To all FASTRON Customers

Ref no: 000207

**Concerning Part Name:** All PISM models

**Classification of Change:** Ferrite core material and dimension

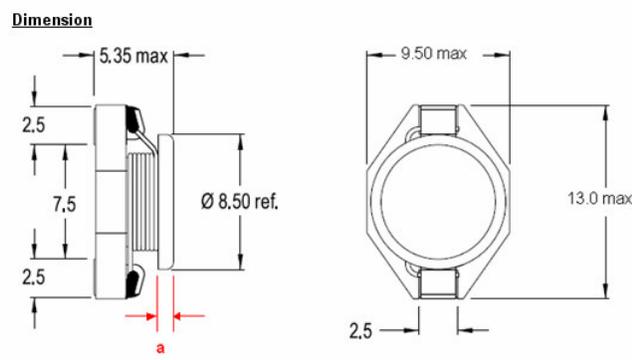
**Description of Change:** The core material changed to a more robust ferrite material and dimension "a" has become thicker.

Before improvement	After improvement
Dimension "a" (typ.)	0.75 mm	0.90 mm

**REASON:** To improve the stability and strength of the ferrite core.

**RESULT:** Strength test before change: Average 27.4N  
 Strength test after change: Average 54.2N

**Expected Influence:** No influence on electrical parameters.
